AGENDA

January 19, 2017 Standards Committee Meeting

RE: Agenda for the January 19, 2017 Standards Committee Meeting

720-CBCA-01 PIPE CATCH BASIN CASTING (WITH MARKUPS)

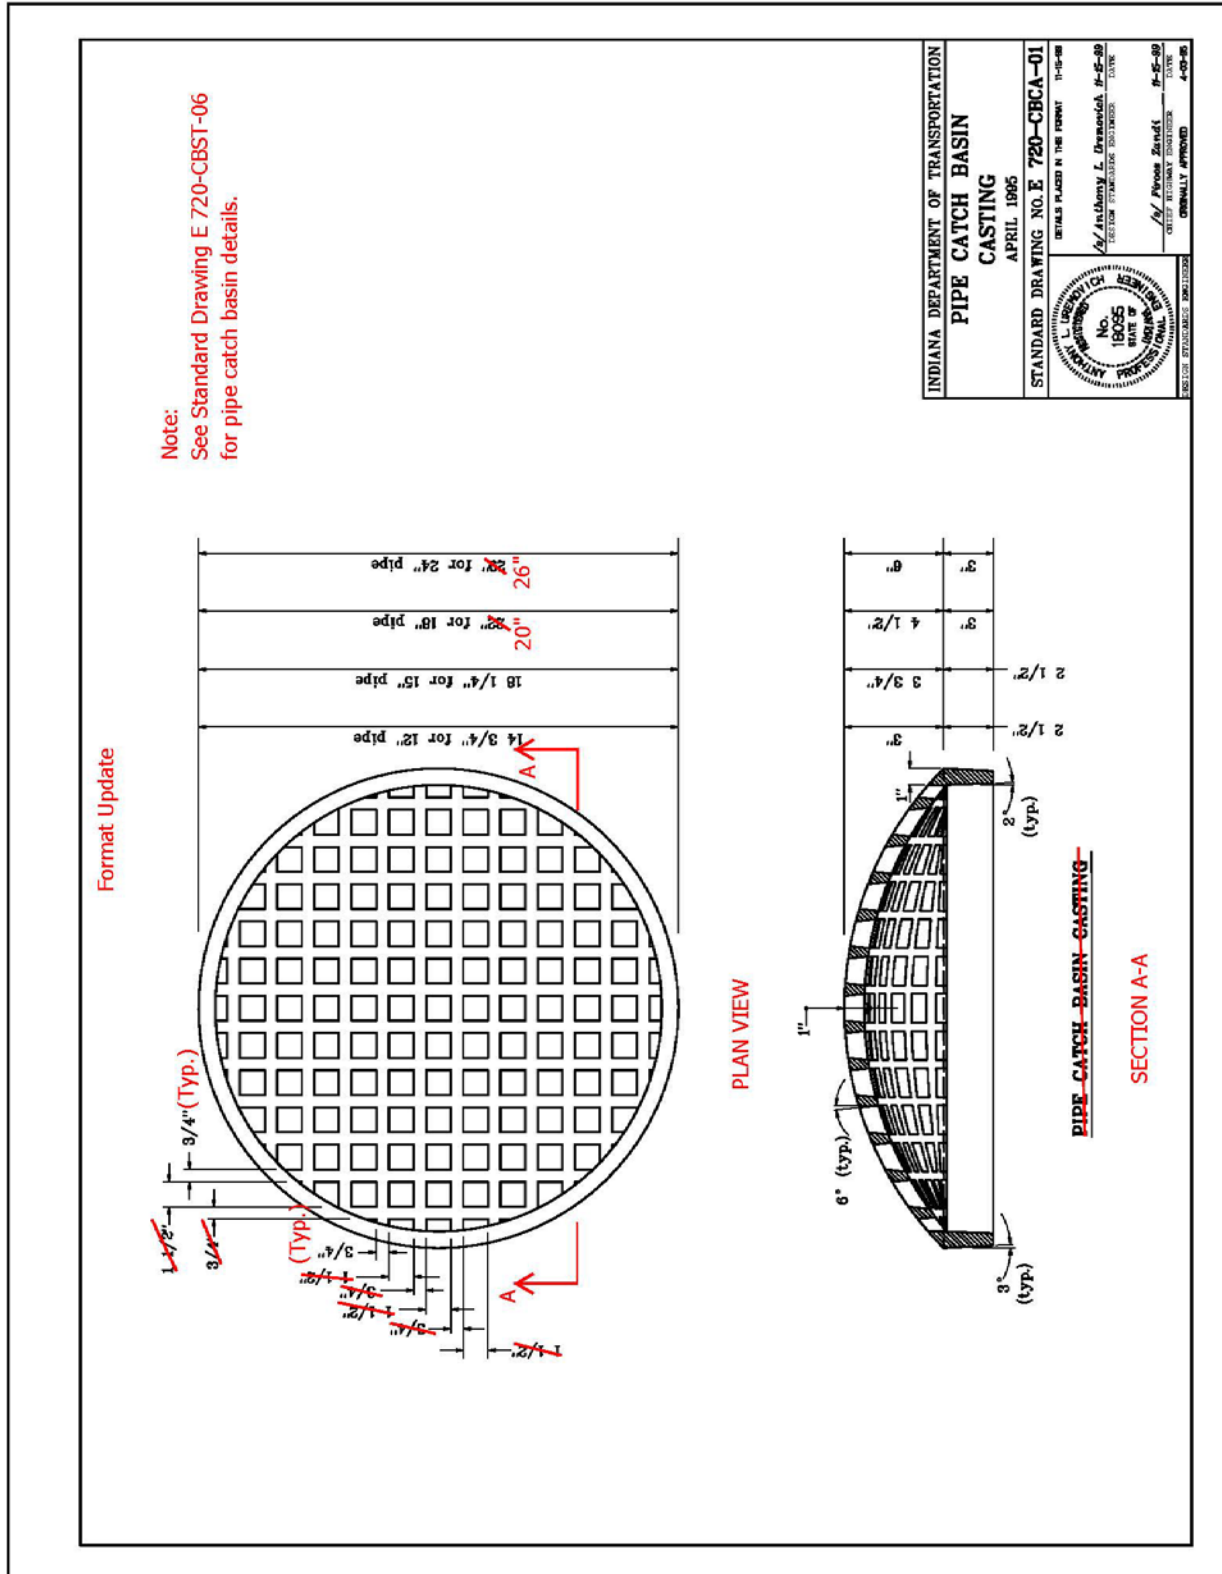
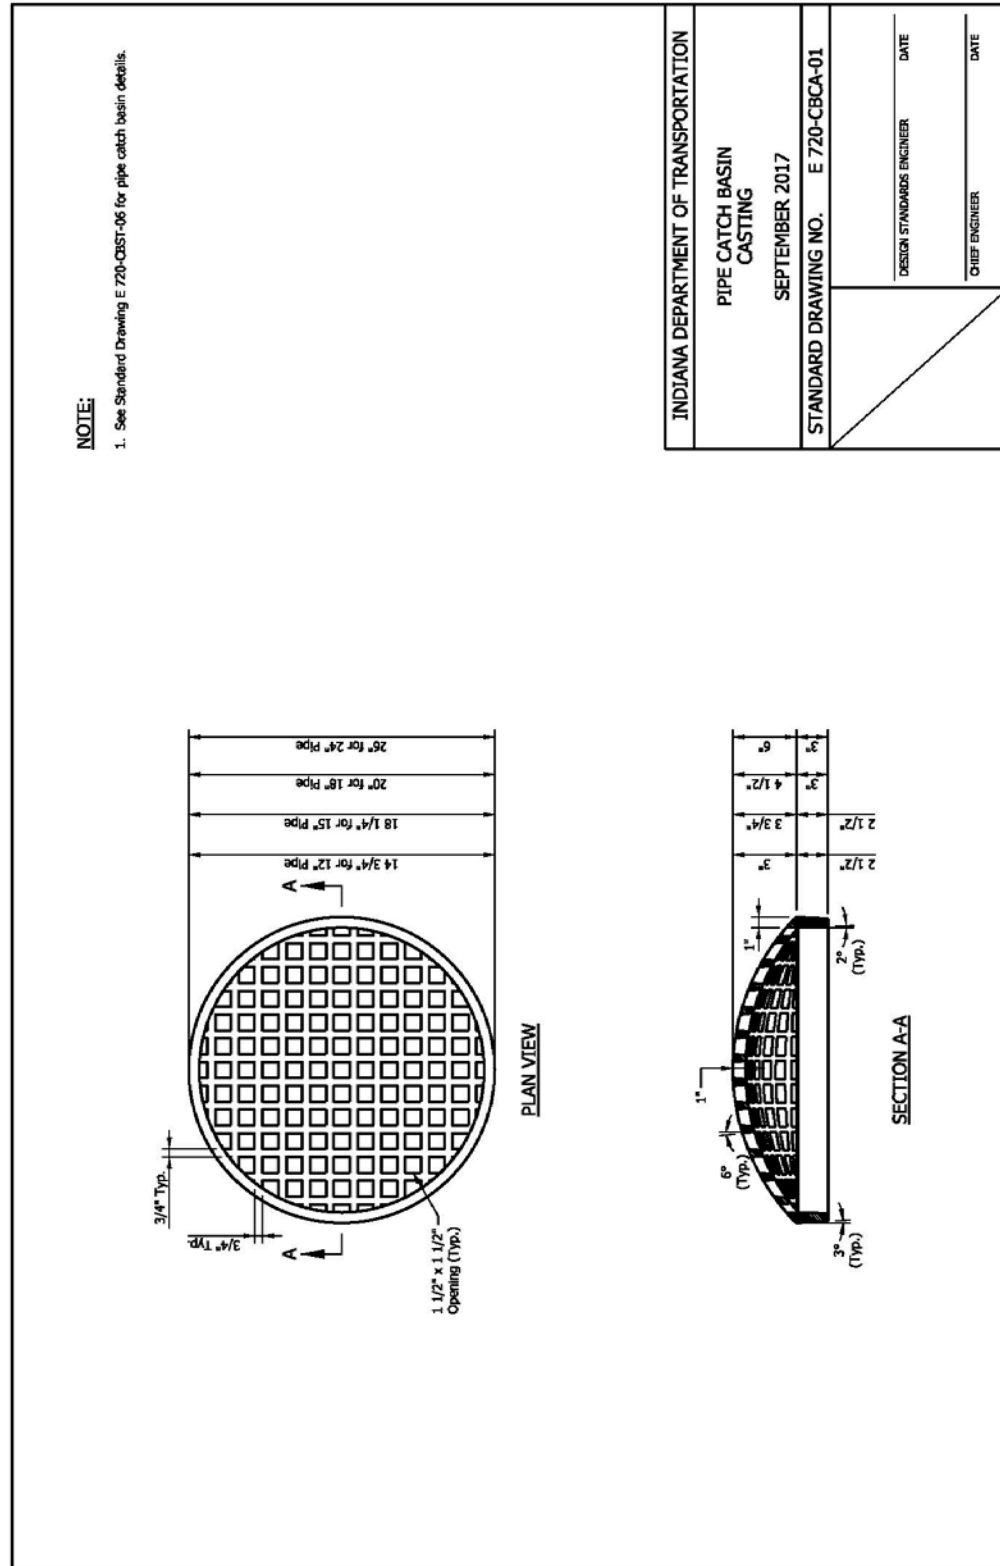
PROBLEM(S) ENCOUNTERED: Pipe basin providers are no longer making catch basin pipes with bell sizes that fit the pipe catch basin castings described in standard drawing series E720-CBCA-01.

801-TCDT-01 RURAL DETOUR (WITH MARKUPS)

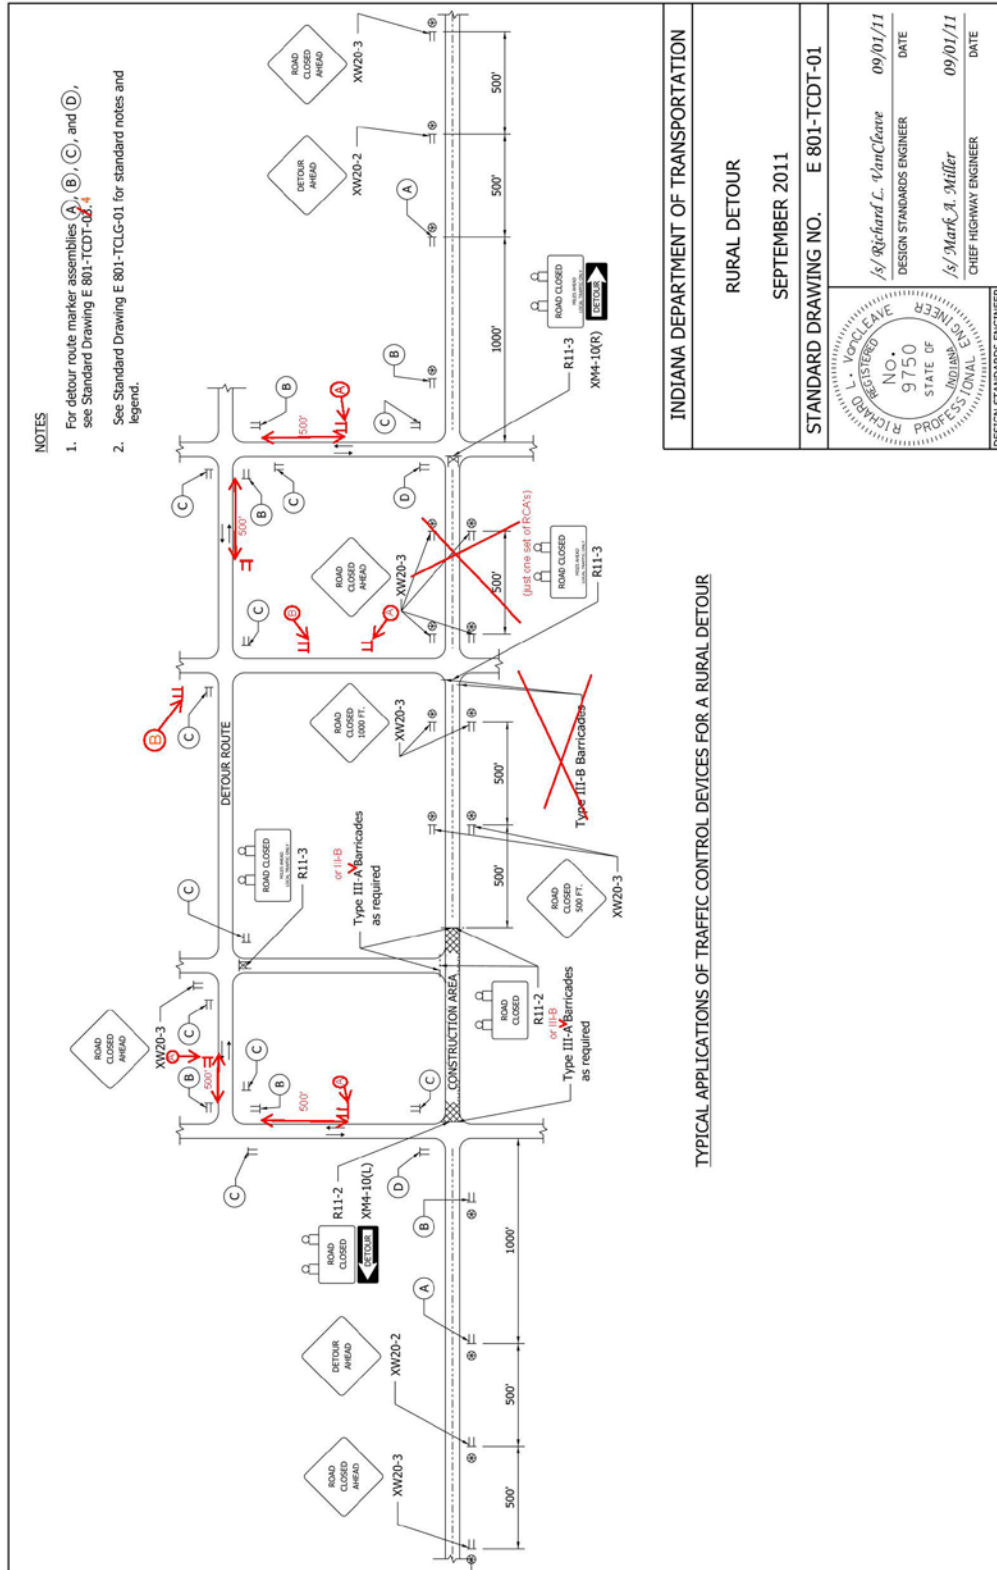
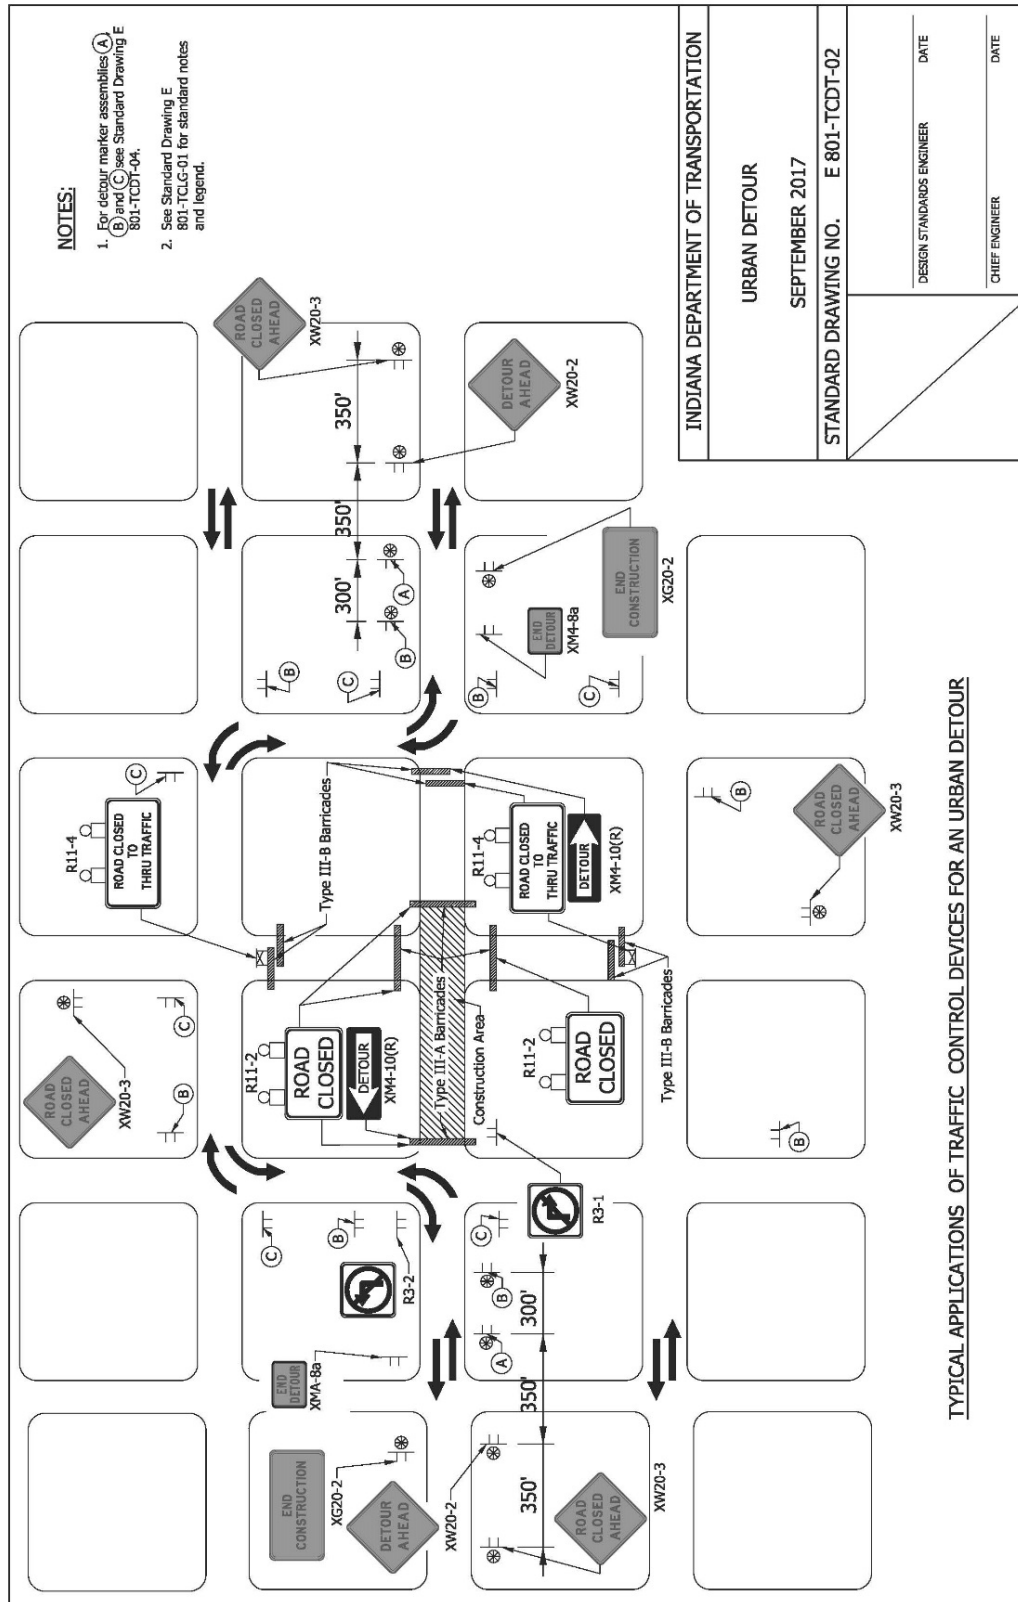
PROBLEM(S) ENCOUNTERED: The existing detour standard drawing series does not show all the signs that are needed for rural and urban detours (e.g. "Road Closed Ahead", "End Detour", etc.) nor are the barricades shown properly on some of the side street approaches. Also the current drawing for urban detours details a one-way pair scenario that could be simplified where two way traffic is maintained on the detour route.

PROPOSED SOLUTION: Update the 801-TCDT series to show the end detour assembly and the set-up for cross streets on a two-way street urban detour.

REVISION TO STANDARD SPECIFICATIONS AND STANDARD DRAWINGS
802-SNGS-01 ROUTE MARKER DETAILS (WITH MARKUPS)

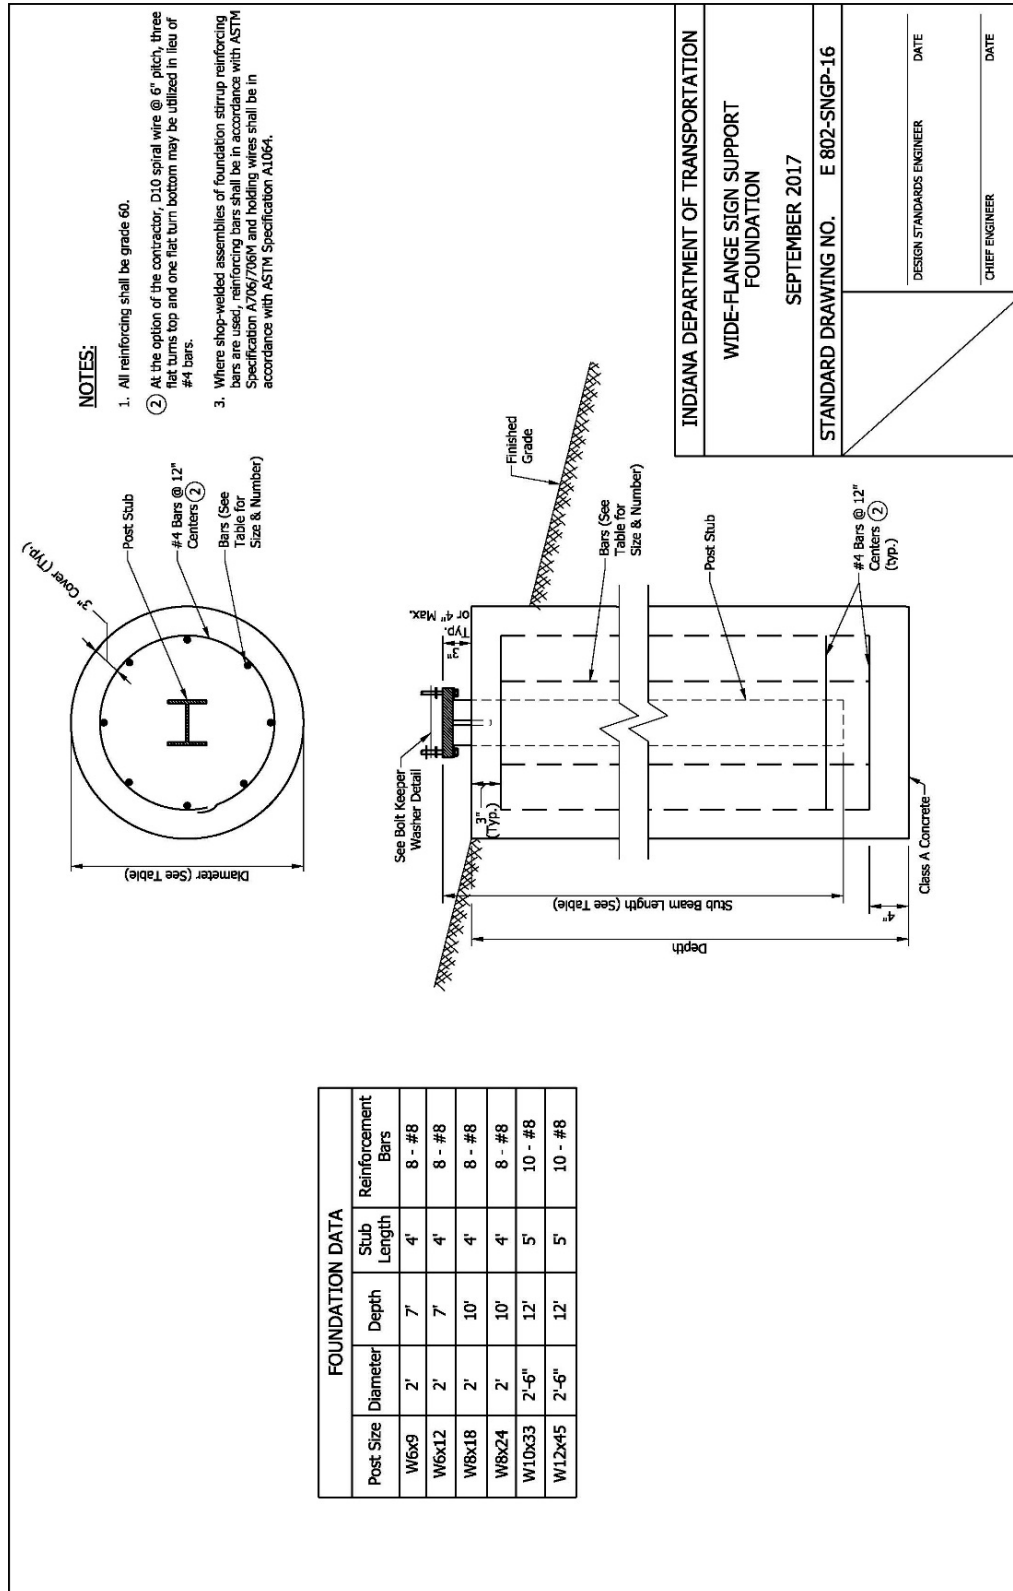
Combine with sheet 02

Move details to sheet 01

Add notes from sheet 04:

5. <u>Center align</u> visually space numbers about vertical centerline of shield.	Move note 5 to sheet 01.
6. Wherever white is specified herein as a color, it is understood to include silver-colored reflecting coatings or elements that reflect white light.

802-SNGS-07 MISC. SIGN DETAILS (WITH MARKUPS)

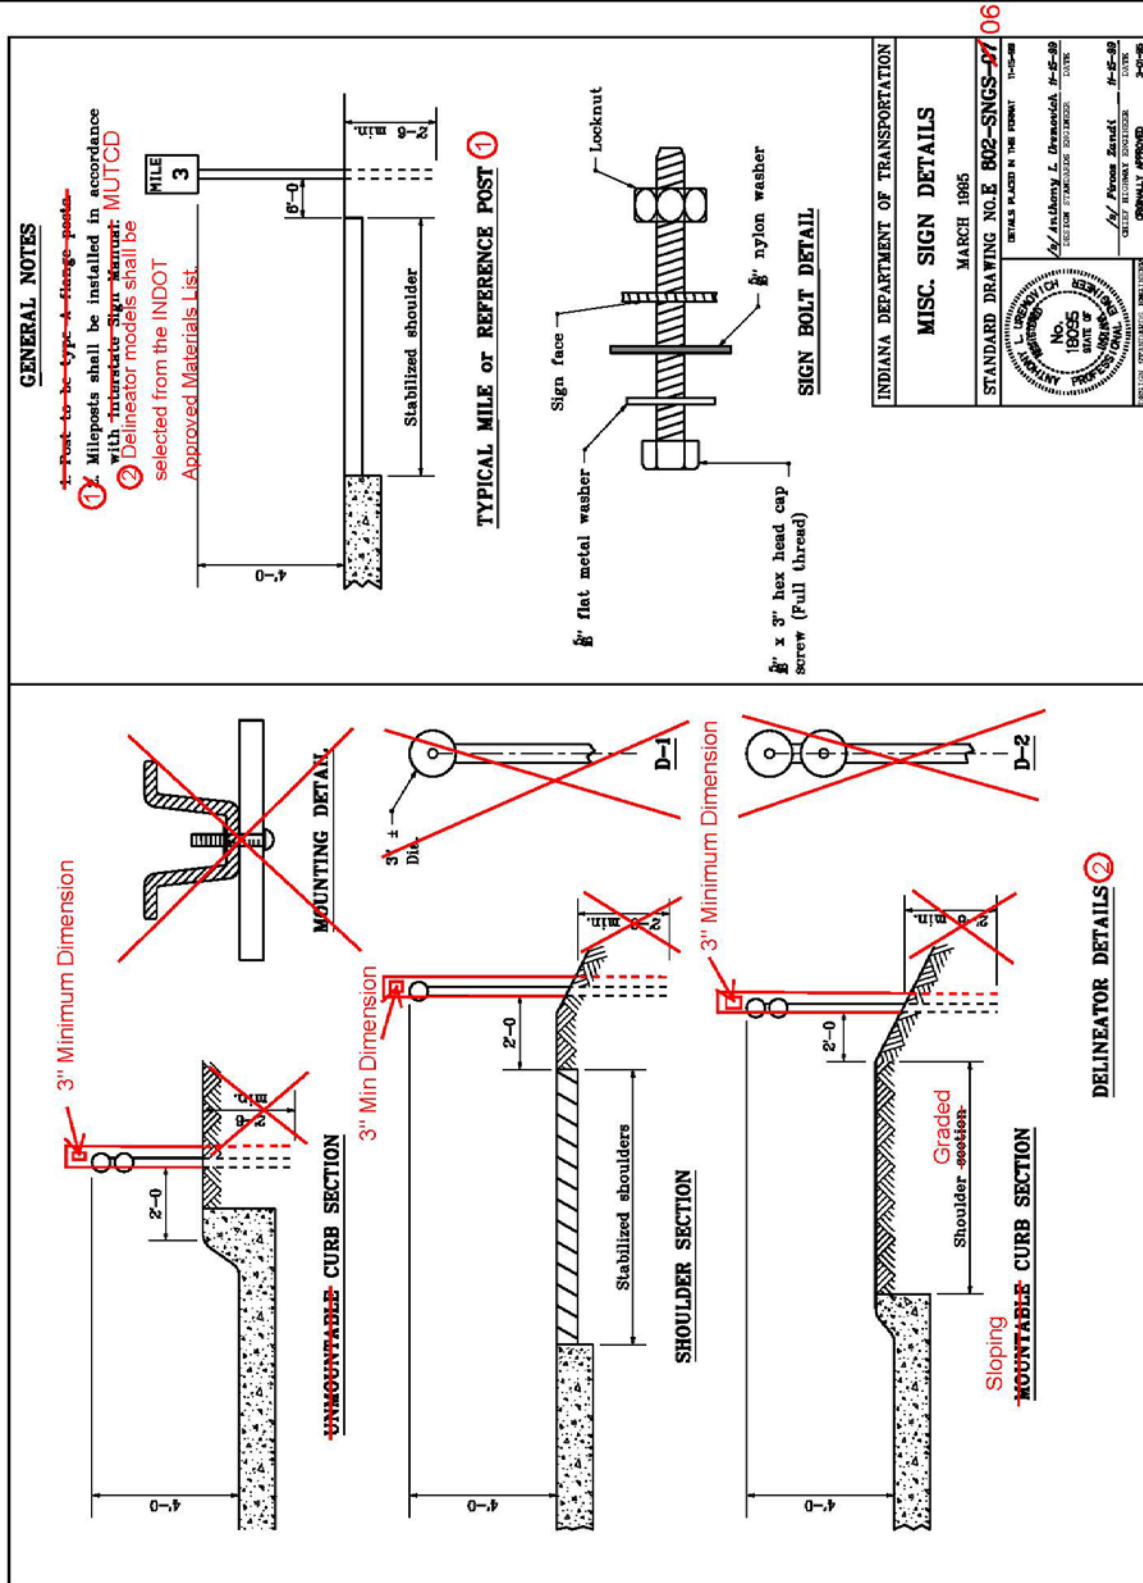
Move to sheet -07

Move to sheet -09

Move to sheet -07
